# NEWPARK

RE: UDPRP Advice for One Newpark, Presented to the Panel on October 23, 2020

[EXHIBIT A]

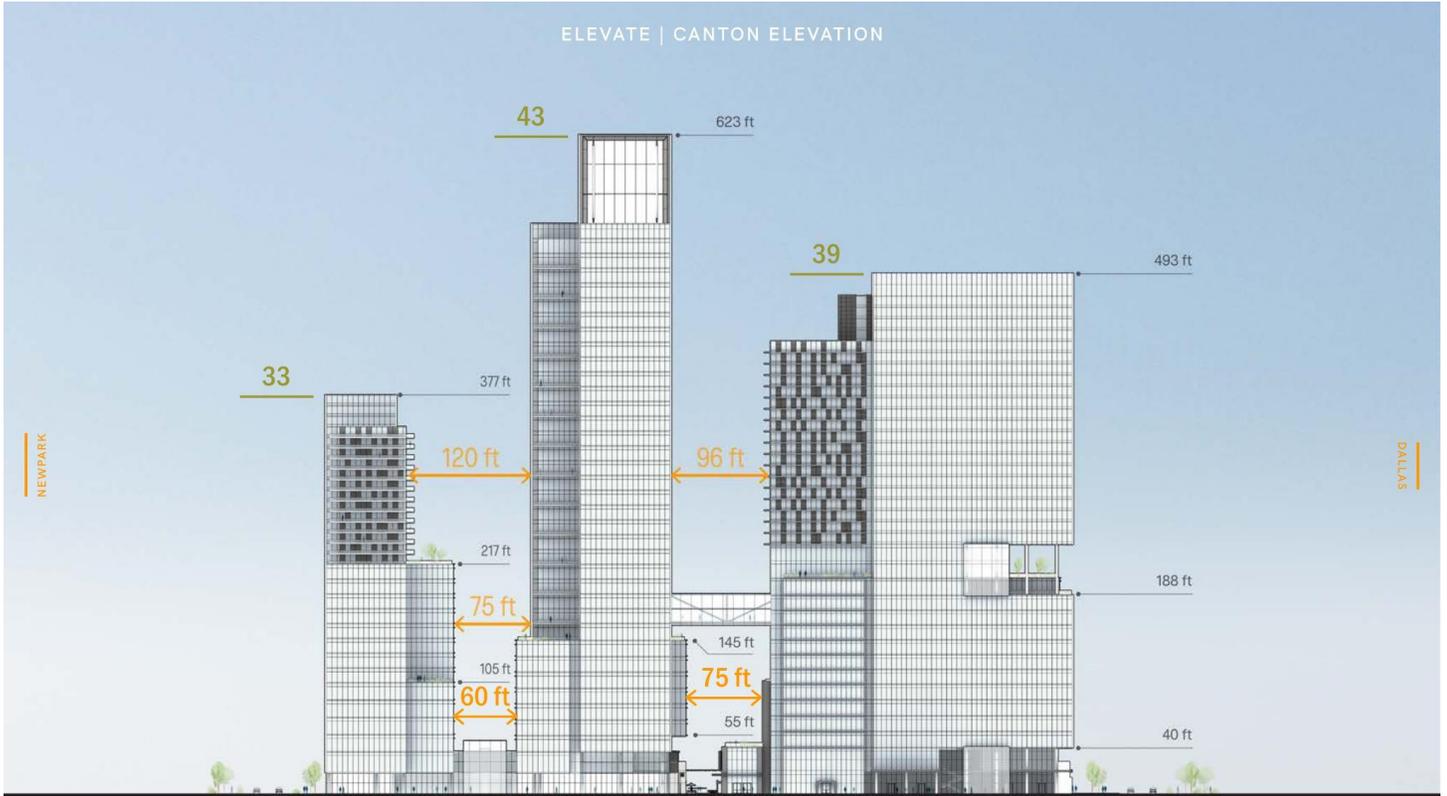
- [5] The Panel recommends the design team consider softening the façade along Canton Street to help balance the monumentalism that exists at and around Dallas City Hall.

Response: Due to the cores of the multiple mix of uses and structural grids necessary to support all the uses stacked vertically in the building, it will be financially unfeasible to make significant changes to the façade along Canton Street. Please see Exhibit A that illustrates how the façade along Canton Street has been designed further to develop the building in a manner that is appropriate for a downtown high-rise in the setting which is appropriate for significant density and urban form.

[EXHIBIT B]

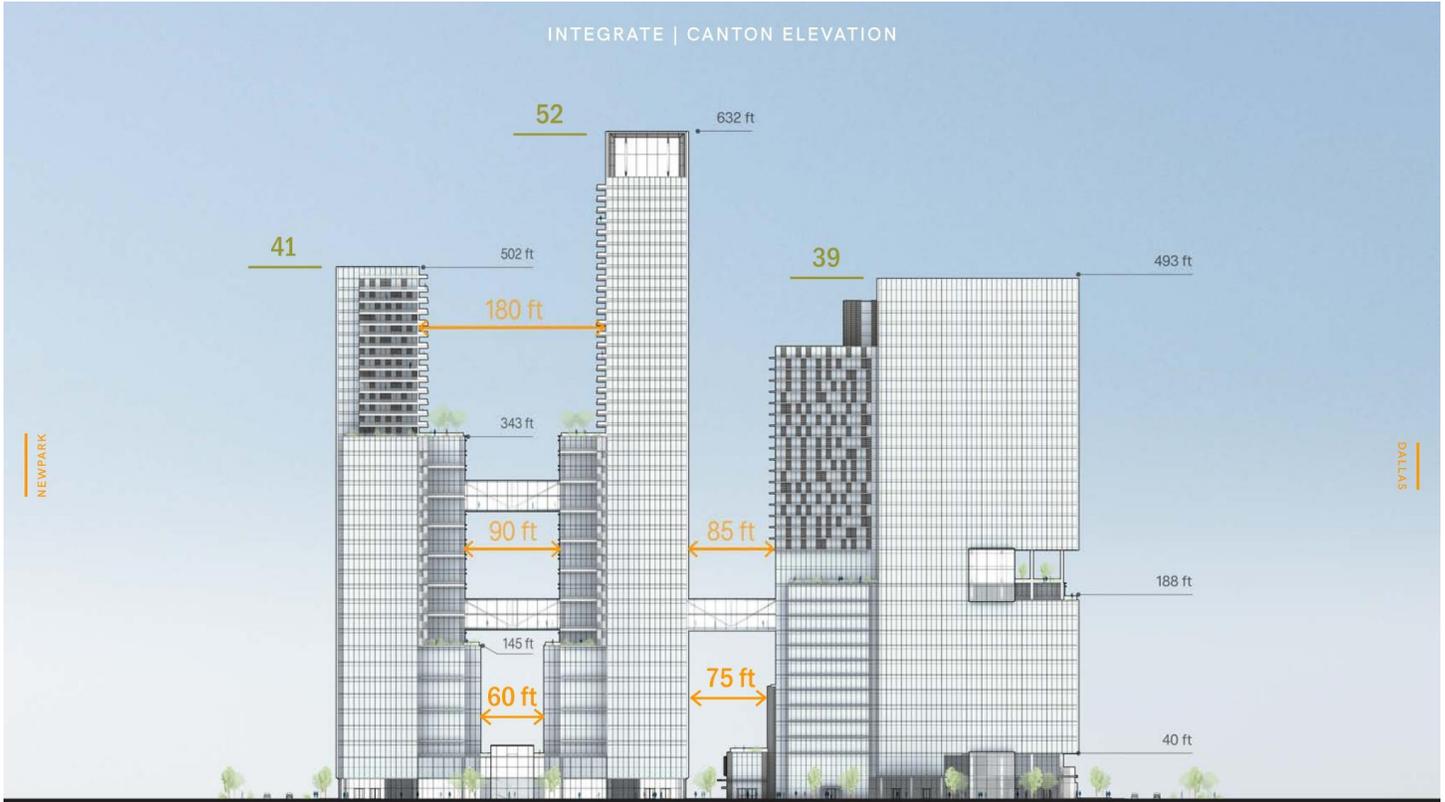
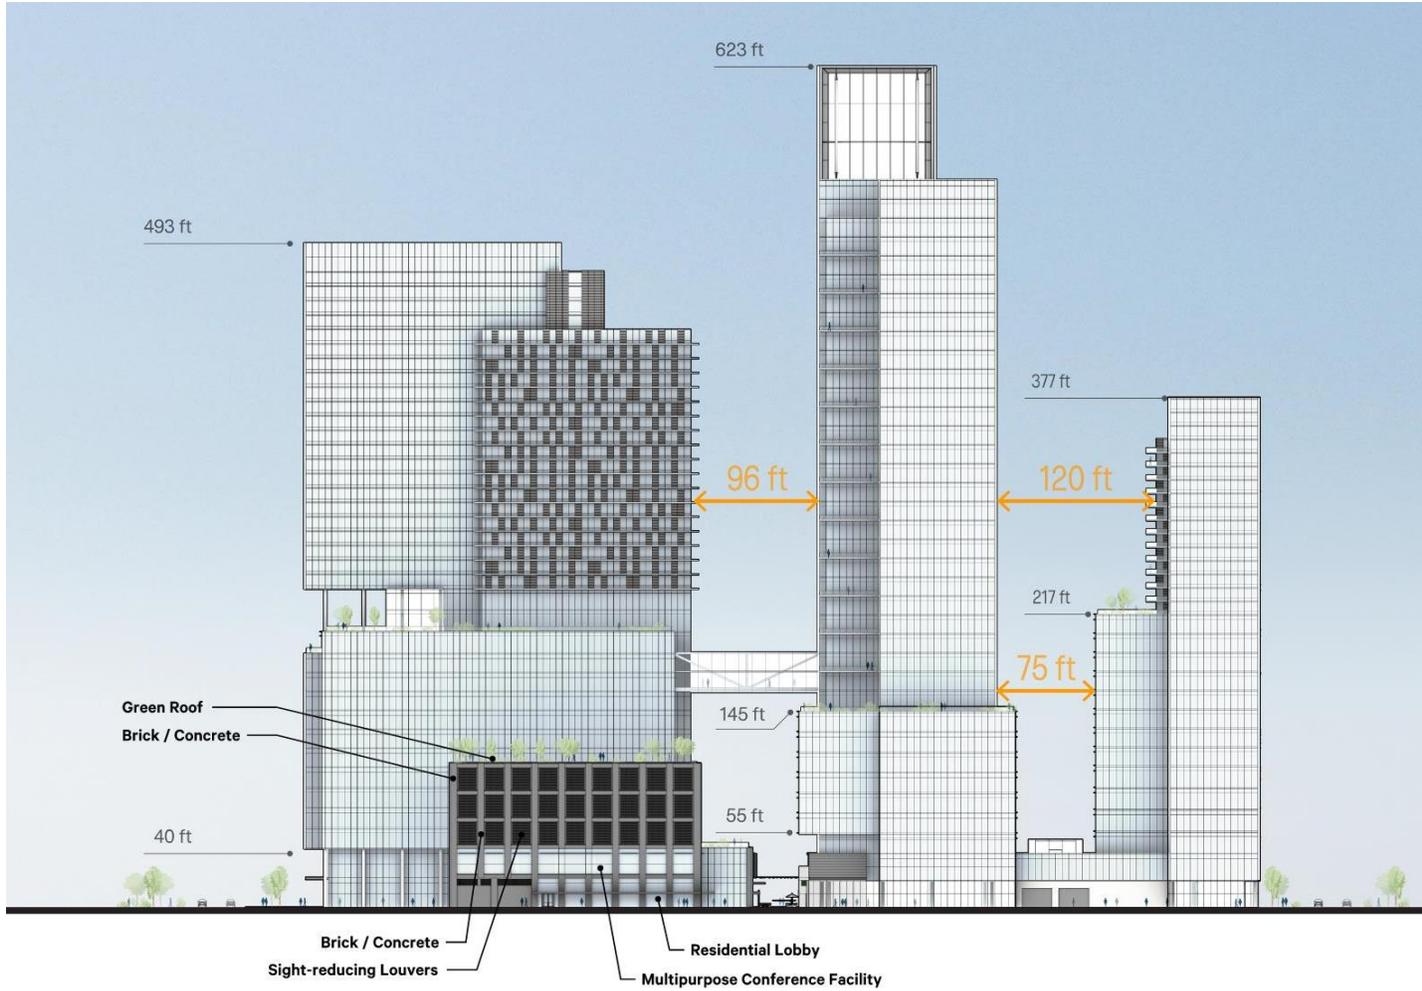
- [6] The Panel advises that the overall master plan work with this phase and future phases and their massing to mitigate the feeling of a wall, including thought being given to the design of future pedestrian mews between Canton and Cadiz to break down this barrier.

Response: Please see Exhibit B illustrating refinements to the overall master plan in order to address concerns of the massing feeling like a wall.

[EXHIBIT C]

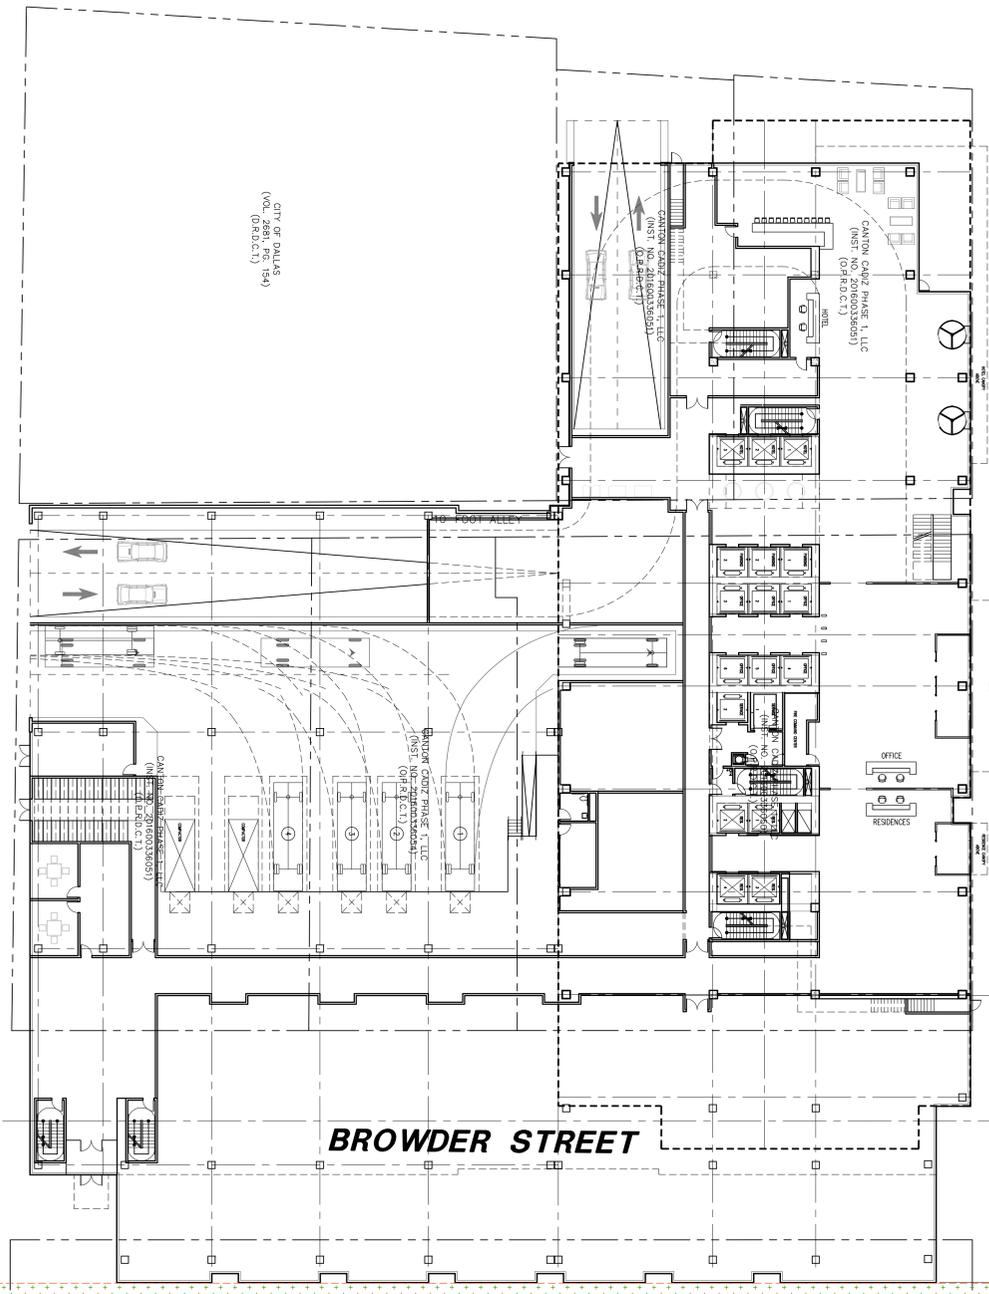
- [8] The Panel expresses concern about the design of the facades of the parking structure, especially on the rear-side of the building facing the fire station property.

Response: Please see Exhibit C illustrating the design intent for the building materials on the garage and how the facades of the parking structure are activated on all sides. All sides of the parking garage will be skinned with building materials to ensure all sides of the building are activated.

[EXHIBIT D]

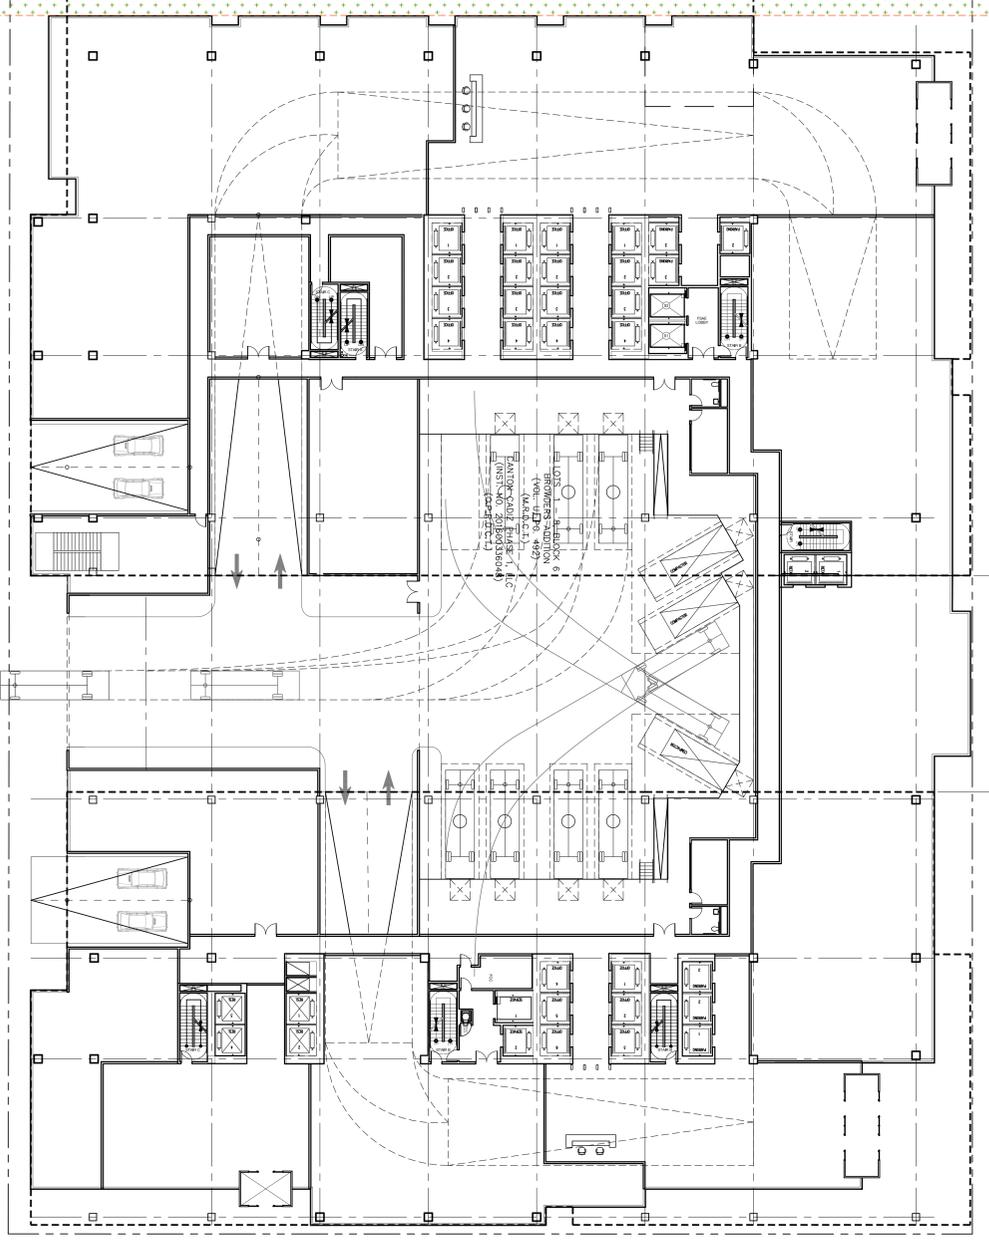
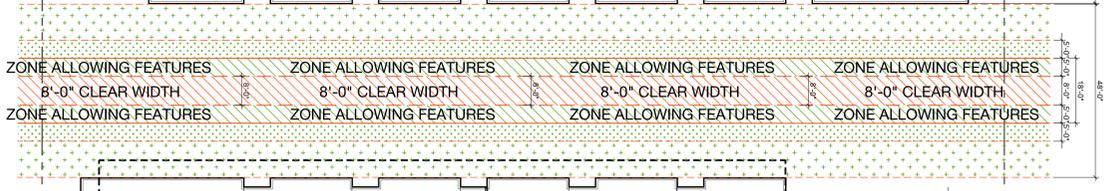
*Response: We have met with City departments regarding proposed street changes and bike infrastructure improvements, and we will continue to work hand-in-hand with them.*  
*City Response (3.10.21): Per the abandonment request of Browder, please provide a plan diagram of the proposed pedestrian mews replacing Browder Street, indicating dimensions of the space and the sidewalk.*

Newpark Response: Please see Exhibit D attached.

[EXHIBIT E]

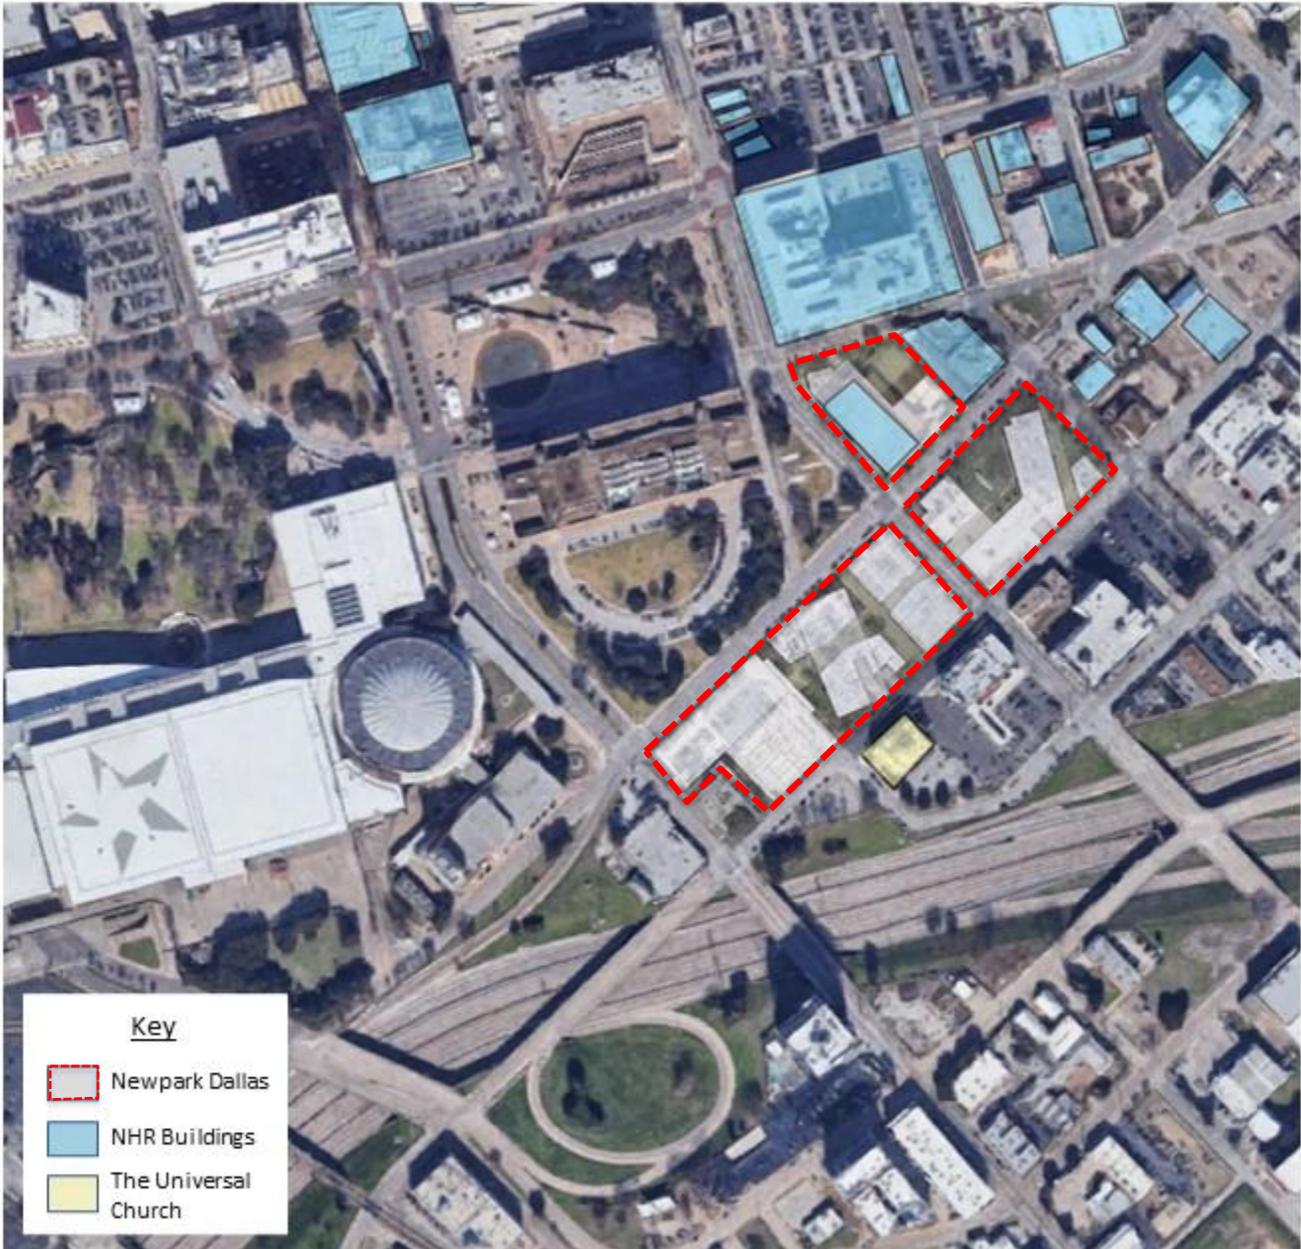
City Response (3.10.21): Please provide a plan diagram of the NewPark master plan, highlighting all of the historically significant buildings that are indicated in the Downtown Dallas National Register District report (previously shared, and included in this response). Please indicate any impacts that might exist with any of the listed buildings.

Newpark Response: Please see Exhibit E attached. The diagram shows the Newpark master plan and surrounding historic structures. The Newpark team has been very intentional about designing a project that is respectful and responsive to historic structures around the site. The Eagles Nest (referred to today as The Universal Church), for example, contributes greatly to the context of the streets around Newpark and the 1 Newpark residential front door and pedestrian mews between 1 Newpark and 2 Newpark are designed to open up to this historic building. 1701 Canton was reviewed by the City of Dallas Office of Historic Preservation and granted a demolition permit following a public hearing and process due to an inability to repurpose the building for the intended future use, which we can now share is a flagship downtown school for the local public school district.
